DESIGN CHANGE NOTICE – CHANGE ORDER No. 002

Kanaka Creek Road Improvements

Date: August 28, 2017
 Federal Aid: TA5527
 State Contract: N/A
 Contract: _____
 Projects: Kanaka Creek Road Improvements
 Change Order: 002

CITY OF STEVENSON
KANAKA CREEK ROAD IMPROVEMENTS
KANAKA CREEK ROAD PLAN AND PROFILE
STA 50+00 TO STA 53+48

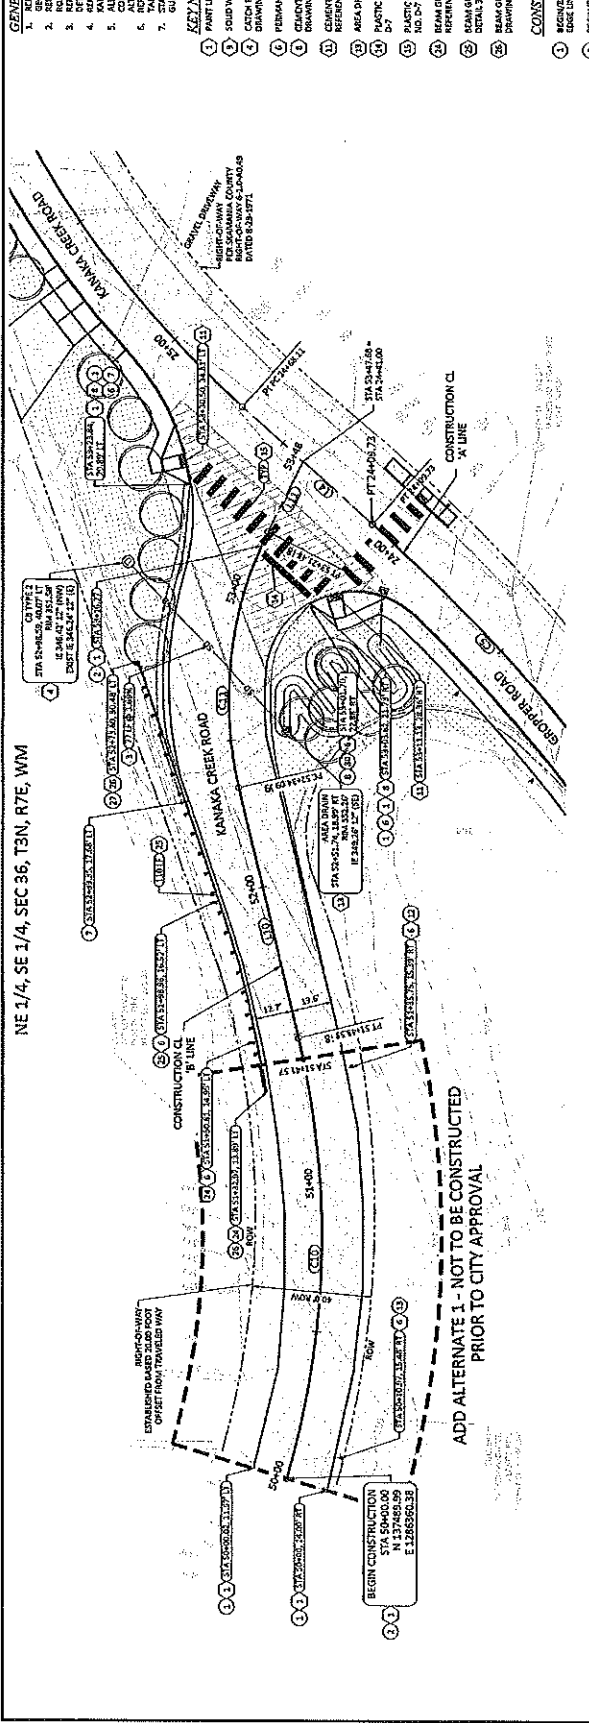
The scope of this design change notice is to address the unsuitable soils discovered beneath the old Kanaka Creek Road/Gropper Road intersection. The original design included reconstruction of the intersection. The underlying clay and silty soils are not appropriate subgrade material for a roadway expected to receive heavy traffic. The proposed change will increase the excavation depth below the intersection and will include construction of a sturdier subgrade to extend the service life of the new pavement.

Where unsuitable subgrade is found within 6 inches of the bottom of the proposed road base (reference attachment for location), Crestline shall over-excavate the subgrade 0'-6" in depth. The subgrade remaining shall be compacted to a depth of 6 inches to 95% standard density (per WSDOT Spec 2-06.3(2)). A GEOTEXTILE FOR SEPARATION conforming to WSDOT Spec. 9-33 shall be placed after the over-excavation and in other areas within the travel lanes that are exposed to unsuitable soils. STRUCTURAL FILL or equivalent shall be placed over the excavation (to 0'-6" depth) as discussed in the project's Contract Documents geotechnical report. Above the structural fill, construction shall follow per the original contract documents (4-inch HMA over 2-inch CSTC over 6-inch CSBC).

Bid Item 7: Roadway Excavation Incl. Haul: +40 CY @ \$17.00	\$680.00
Add Bid Item 53: Construction Geotextile for Separation: 314 SY @ \$3	\$942.00
Add Bid Item 54: Structural Fill: 74 TON @ \$41	\$3,034.00
Total this Change Order	\$4,656.00

CALCS: $2156 \text{ SF} \times 6" = 40 \text{ CY} - \text{EXCAVATION}$
 $40 \text{ CY} \times 1.85 \text{ T/CY} = 74 \text{ TON} - \text{STRUCTURAL FILL}$
 $2819 \text{ SF} = 314 \text{ SY} - \text{GEOTEXTILE}$
